UNITED STATES PATENT AND TRADEMARK OFFICE

APPLICATION NO.	FILING DATE	FIRST NAMED INVENTOR	ATTORNEY DOCKET NO.	CONFIRMATION NO.
10/534,690	10/12/2005	Yoshiyuki Ochi	DK-US055091	5600
22919 7590 02/07/2008 GLOBAL IP COUNSELORS, LLP 1233 20TH STREET, NW, SUITE 700 WASHINGTON, DC 20036-2680			EXAMINER KASTURE, DNYANESH G	
			ART UNIT 4147	PAPER NUMBER
			MAIL DATE 02/07/2008	DELIVERY MODE PAPER

Office Action Summary

DETAILED ACTION

Fig. 1

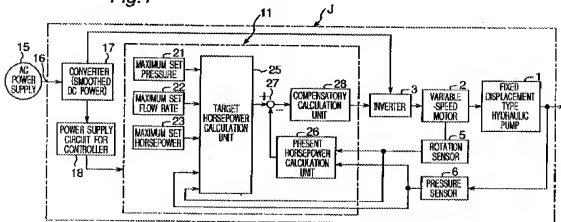
22. In Re claim 1, with reference to Figure 1 depicted above, Horiuchi et al discloses a pump driving method comprising:

- driving a motor (2) using a controller (11) based on a horsepower command value using a discharge pressure – discharge flow characteristic (as described on Page 4, Paragraph [0021])

- carrying out feedback control of the discharge pressure using the signal from the pressure sensor (6) (as described in line 3, Page 4, Paragraph [0021])

- driving a pump (1) using motor (2) (as described in line 14, Page 4, Paragraph [0021])
- the pump (1) inherently changes its pressure/flow rate when the AC power source voltage drops due to the lowering of the input horsepower as a result of the drop in power voltage. This condition is temporary until the controller judges which region the present operating state belongs to and acts accordingly to stabilize the pump. If the voltage drop is significant, the controller may not be able to stabilize the pump since the source input horsepower is insufficient to maintain the new state.

23. In Re claim 6, with reference to Figure 1 depicted above, Horiuchi et al discloses a pump driving apparatus comprising:

- a motor (2) configured to be driven based on a command signal from the inverter (3) using a discharge pressure - discharge flow characteristic (Page 3, Paragraph [0019], line 9)
- to feedback control (27) a discharge pressure (6)

- a pump (1) operatively coupled to motor (2)
- a characteristic changing section (21), (22) where the maximum pressure and flow rate can be changed. Also, the microcomputer element of the characteristic changing section is inherently capable of calculating a new pressure - flow rate characteristic as a programmed function of power voltage input value.

24. In Re claim 9, with reference to Figure 1 depicted above, Horiuchi et al discloses :

- a motor (2) configured to be driven based on a command signal from the inverter (3) using a discharge pressure - discharge flow characteristic (Page 3, Paragraph [0019], line 9) to feedback control (27) a discharge pressure (6)
- a pump (1) operatively coupled to the motor (2)
- an apparatus (11), (21), (22), (23), (25), (27), (28) that is capable of making changes to the control algorithm if necessary, only when the system is stable.
